# Vintage Denim Studio Ltd. #9208

Plot #99 & 102-128, Ishwardi EPZ, Ishwardi, Pabna

07.May.2014

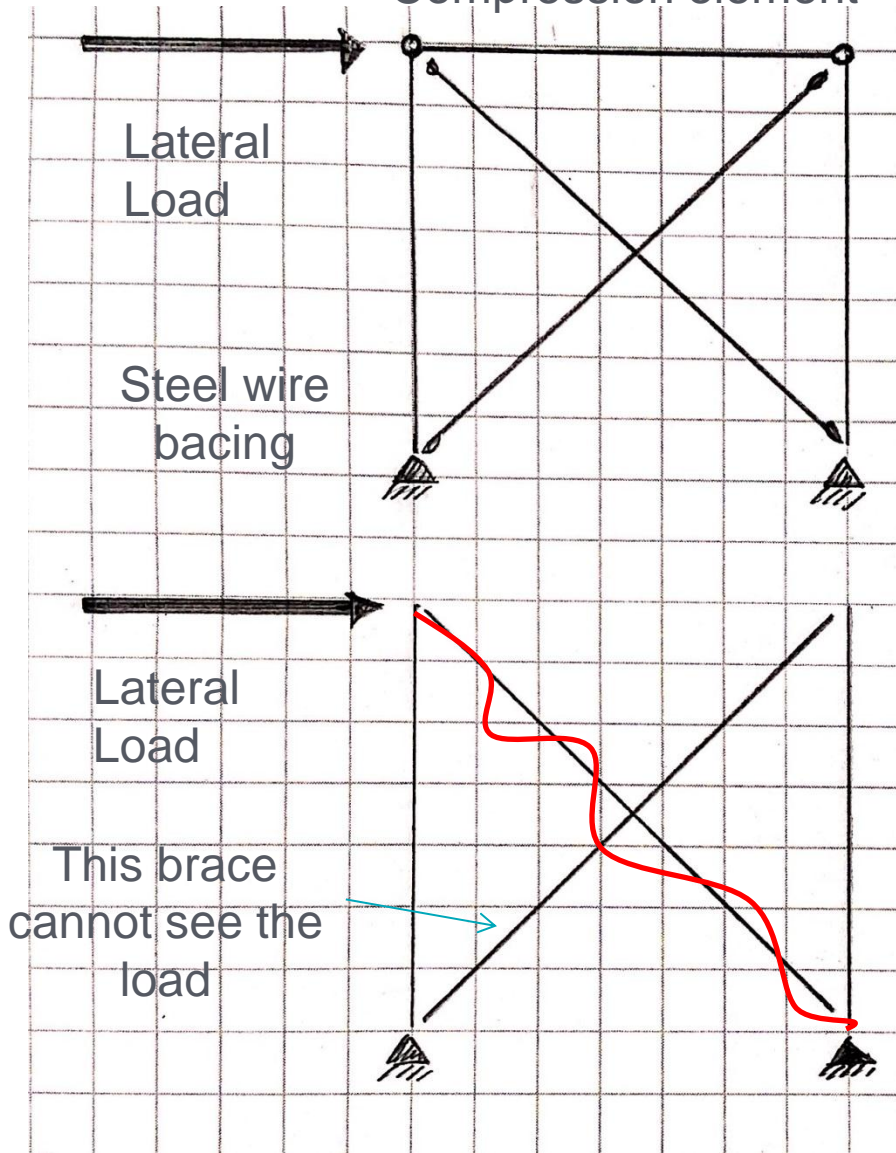
On the picture, we can see that the concrete slabs overlaps the flange of the column. We have found cracking and loose debris that could fall on the workers.

| Item No. | Observation   | Recommended Action Plan  | Recommended Timeline |
|----------|---|--|----------------------|
| 2        | Concrete slab at Main Production Shed should be dissociated from steel columns.           | Clear all loose material that could potential fall on the workers.   | Immediate – Now      |
| 3        | Concrete slab at Main Production Shed should be dissociated from steel columns.           | Demolish the concrete around the column to allow the steel structure to move freely.   | 6-months             |
